**NINE MILE POINT
NUCLEAR STATION**

SUBJECT: Nine Mile Point Nuclear Station
Unit No. 2; Docket No. 50-410

Supplemental Information Regarding Nine Mile Point Nuclear Station, Unit No. 2 –
Re: The License Amendment Request for Extended Power Uprate Operation (TAC
No. ME1476) – Update to License Amendment Request

SUMMARY OF REVISED PEAK CONTAINMENT PRESSURE ANALYSIS (NON-PROPRIETARY)

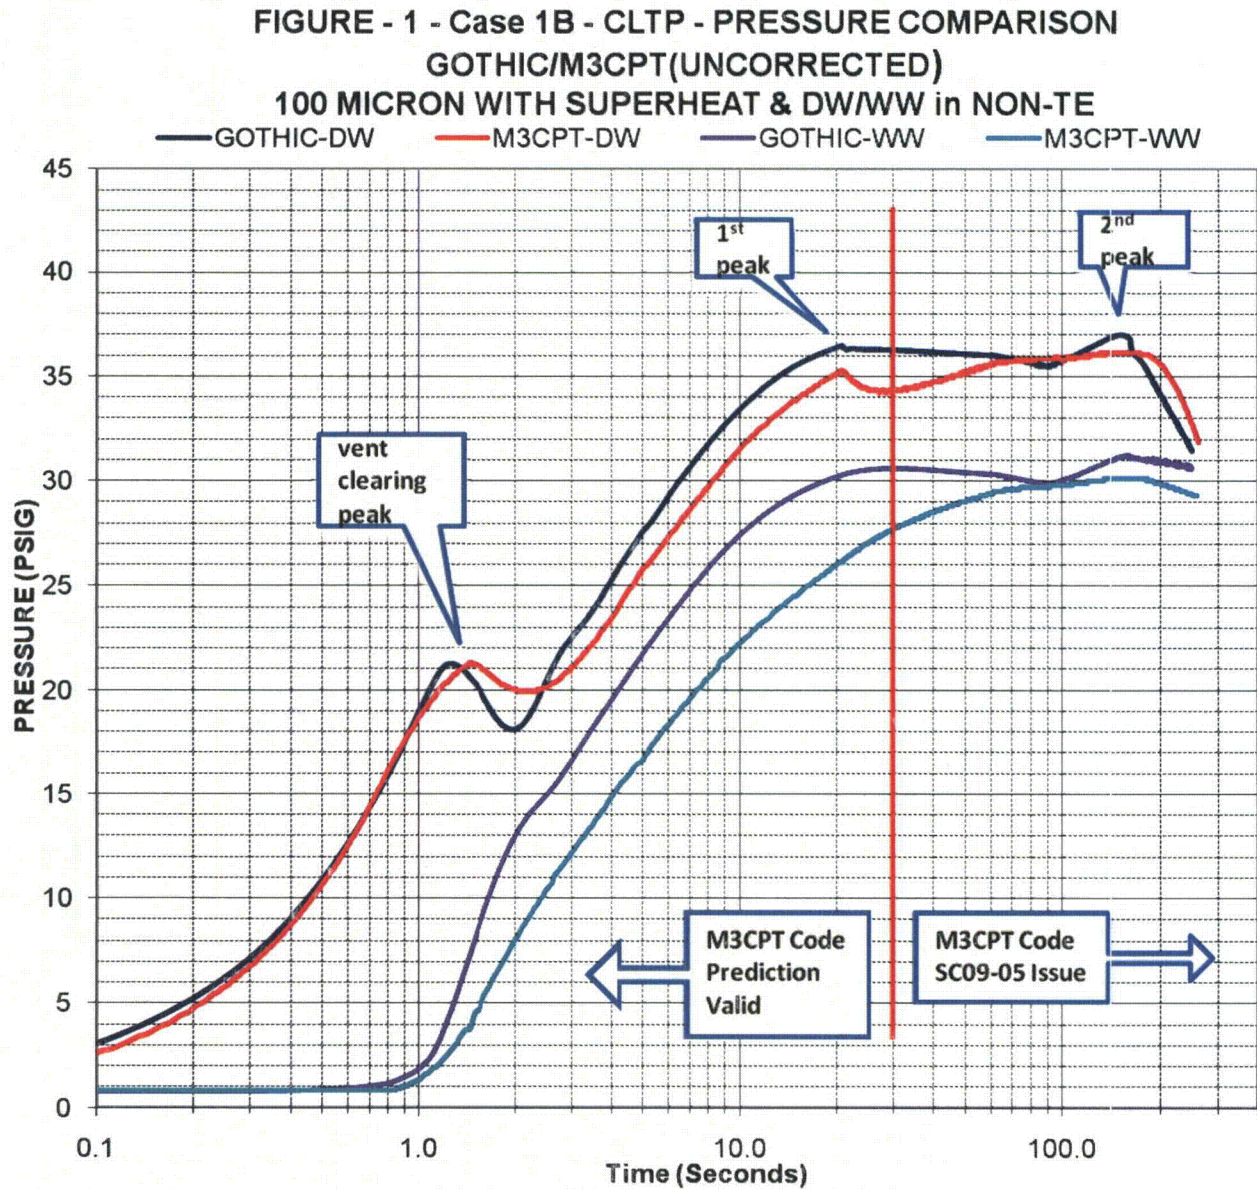
Application of the GOTHIC (7.2b) code, together with a conservative set of assumptions and the drop model, is an appropriate method to resolve the GEH safety communication. GOTHIC is not utilized for any other aspect of the containment short term pressure response. The GOTHIC analysis applies the mass energy release from M3CPT and duplicates the ECCS flows based on the M3CPT assumptions (which ensure these critical inputs are identical). GEH SC09-05 considers M3CPT to be valid for the containment pressure peak that occurs at 21 seconds. The GOTHIC prediction of peak drywell pressure is conservative for the first peak which effectively establishes conservative initial conditions for the resolution of the SC09-05 deficiency in M3CPT. As noted in the table, the GOTHIC model features described above reduce the impact of EPU on the second peak.

Method	Pressure Peaks (psia @ seconds) – 135°F/40%/90°F			Power Level	Figures
	Vent Clearing Peak	1 st Peak (Blowdown Transition)	2 nd Peak (End of Blowdown)		
M3CPT	36.00 @ 1.44	49.90 @ 20.7	50.84 @ 147	CLTP	Figure 1
GOTHIC 7.2b	35.96 @ 1.25	51.18 @ 20.7	51.71 @ 148	CLTP	Figure 1
M3CPT	35.94 @ 1.44	50.24 @ 20.2	51.96 @ 149	EPU	Figure 2
GOTHIC 7.2b	35.95 @ 1.25	51.35 @ 21.2	51.87 @ 152	EPU	Figure 2

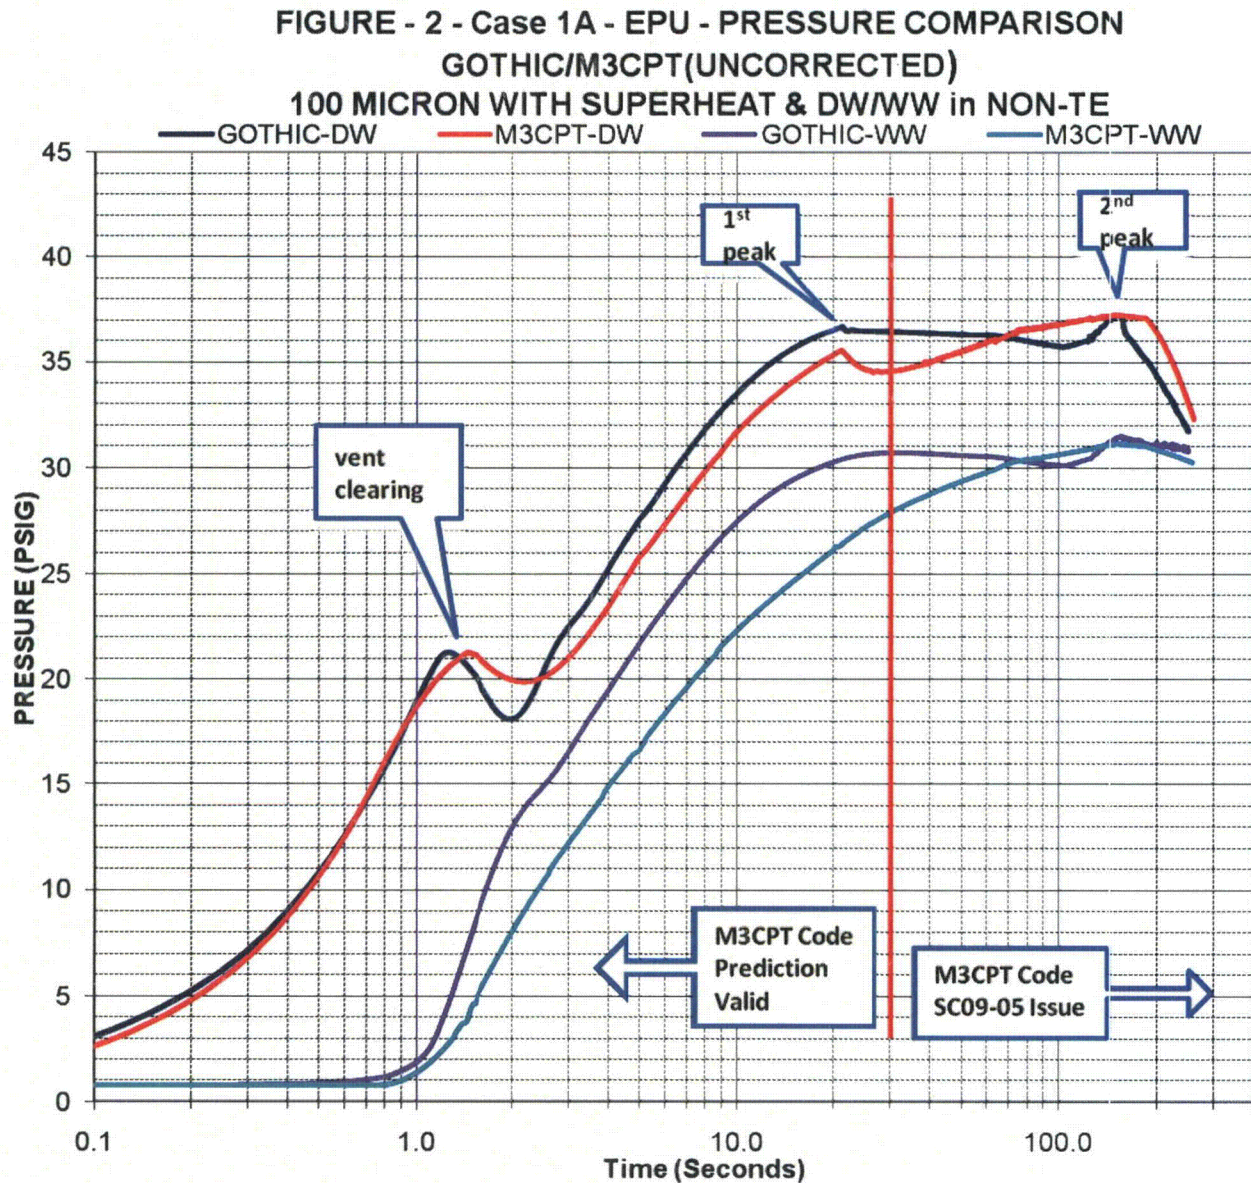
Note: The red vertical line implies that the M3CPT Code SC09-05 issue begins at 30 seconds. This is an approximation. The issue does not have a specific start time, but it is judged to occur after the time shown in the figure.

FIGURE 3 - CASE 2 & 2B - EPU GOTHIC PRESSURE RESPONSE
- 105/40/90 VS. 107/48/83

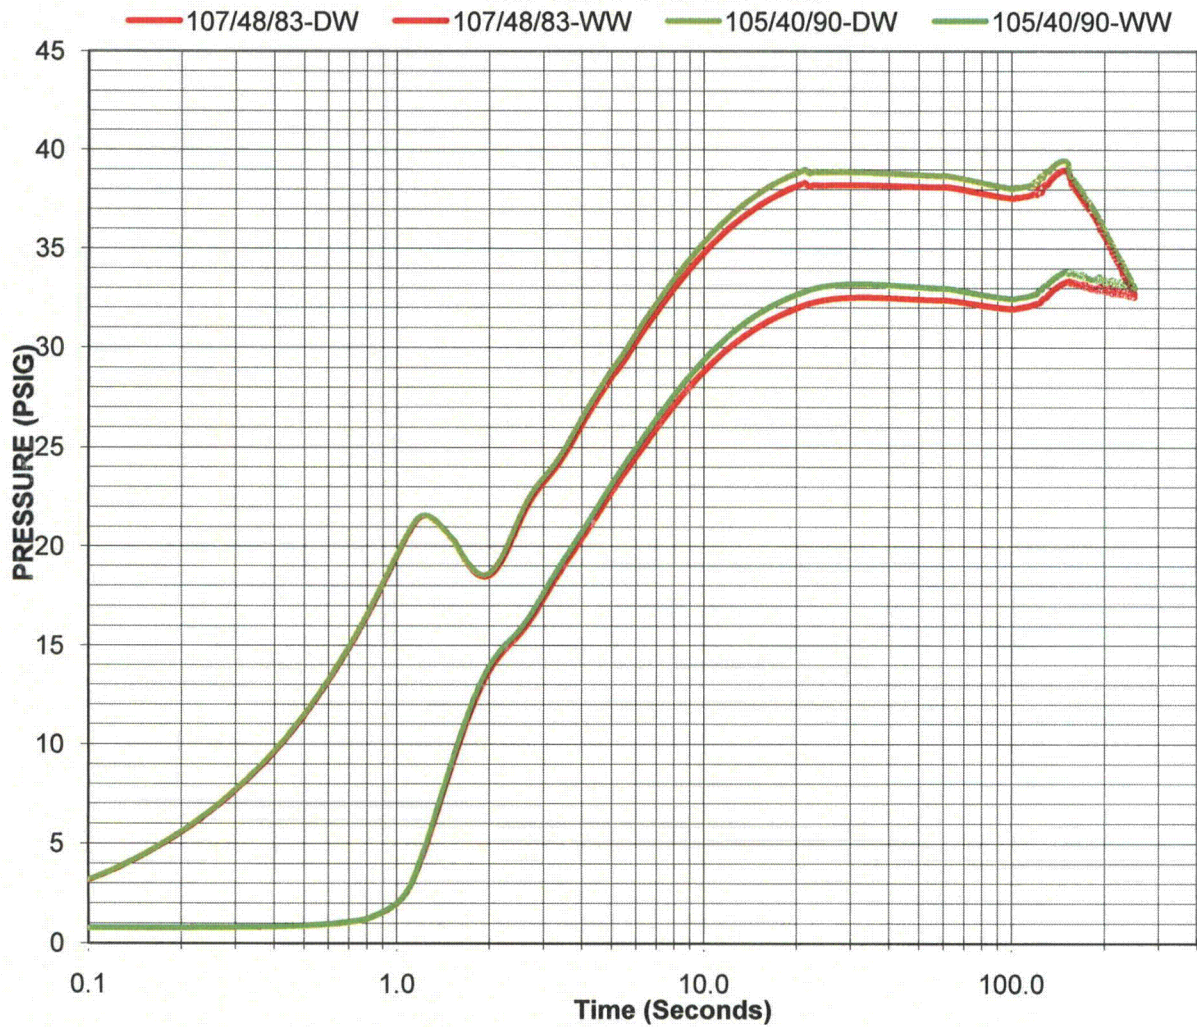
- GOTHIC Case 2B utilizes lower bound initial conditions of drywell temperature of 105°F, drywell relative humidity of 40%, and suppression pool temperature of 90°F.
- GOTHIC Case 2 utilizes a drywell temperature of 107°F (conservative lower bound on the 108.7 °F), drywell relative humidity of 48%, and suppression pool temperature of 83° based on operating plant data review. This case demonstrates the margin with respect to a 97.5 percentile case at 100% power normal operating conditions.
- GOTHIC Case 2A utilizes the initial conditions of drywell temperature of 110°F (mean drywell temperature), drywell relative humidity of 40%, and suppression pool temperature of 90°F. This establishes the sensitivity on drywell temperature while maintaining the other initial conditions at the same values as GOTHIC Case 2B.

Figure 2.6-7 of Attachments 3 and 11 of the NMP2 EPU License Amendment Request dated May 27, 2009 is replaced by Figures 3, 4, and 5 of this submittal. Figure 5 of this submittal shows the Short-Term M3CPT pressure profile used for dynamic loadings. Figures 3 and 4 show the Extended Short-Term GOTHIC pressure profiles used for containment peak pressure analyses.

The revised containment analysis (GOTHIC Case 2B) determined that the peak containment pressure was 54.2 psia (39.5 psig). This value is lower than the value of P_a established in NMP2 Technical Specification 5.5.12.b of 39.75 psig (54.45 psia).

FIGURE 4 - CASE 3 - EPU PRESSURE RESPONSE (70/20/90)

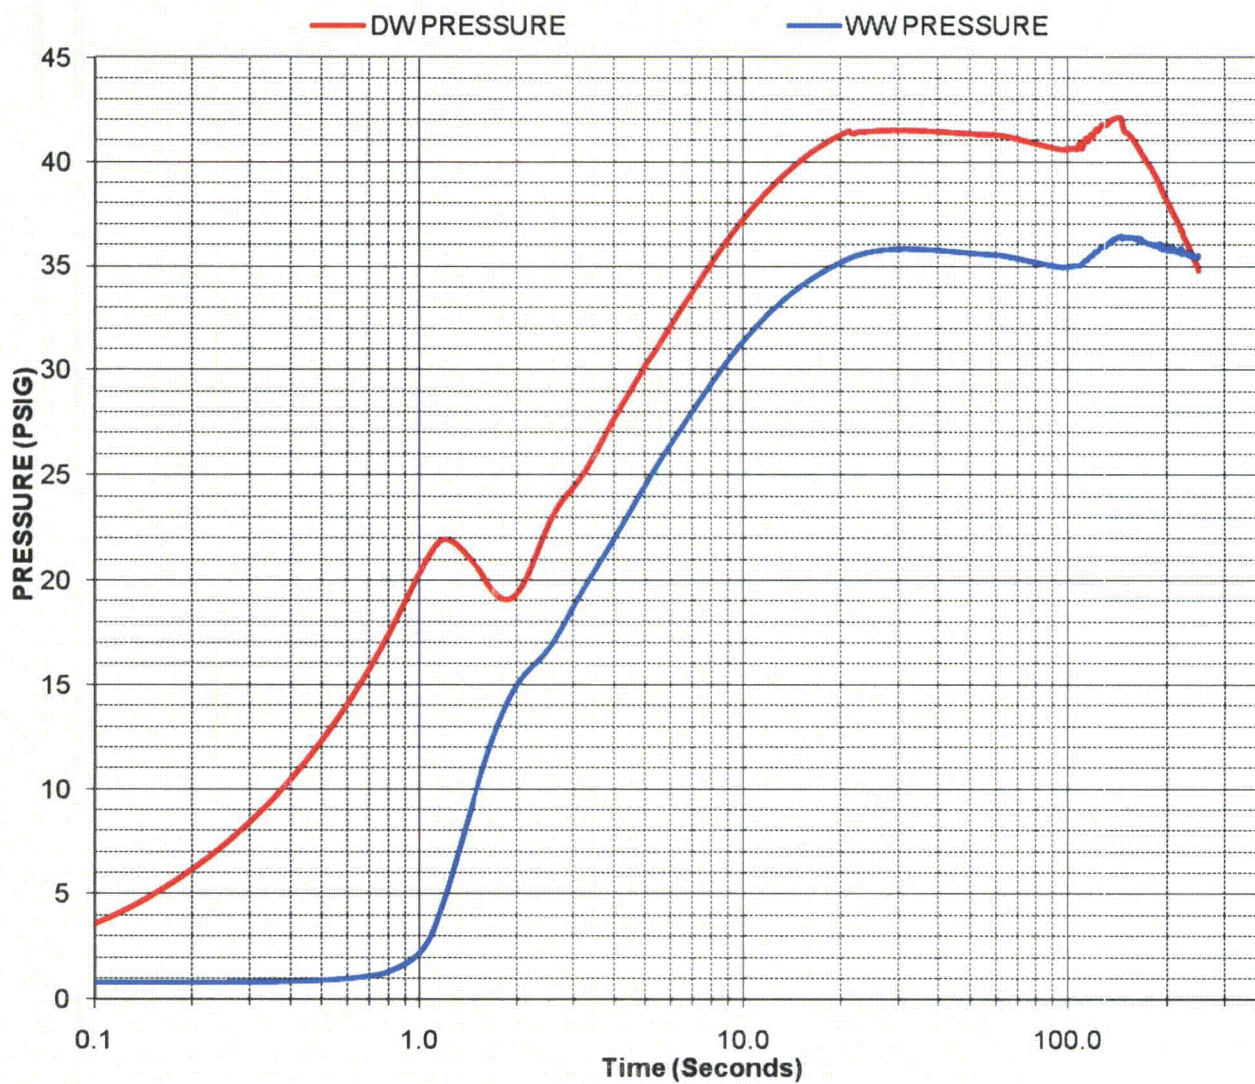
An analysis was performed to ensure that the drywell accident pressures would not exceed design pressure based on the worst combination of initial conditions. GOTHIC Case 3 establishes that the calculated peak containment pressure at the USAR lower bound conditions of drywell temperature of 70°F, drywell relative humidity of 20%, and suppression pool temperature of 90°F is lower than the containment pressure design value of 45 psig (59.7 psia).

Table 2.6-1 of Attachments 3 and 11 of the NMP2 EPU License Amendment Request dated May 27, 2009 identifies that the peak drywell and wetwell pressures for the design basis LOCA EPU with the EPU model as 52.9 and 47.1 psia respectively. The revised containment analysis (GOTHIC Case 3) determined that the peak drywell and wetwell pressures are 56.78 and 51.2 psia. The EPU peak containment pressure is less than the 59.7 psia (45 psig) design pressure.
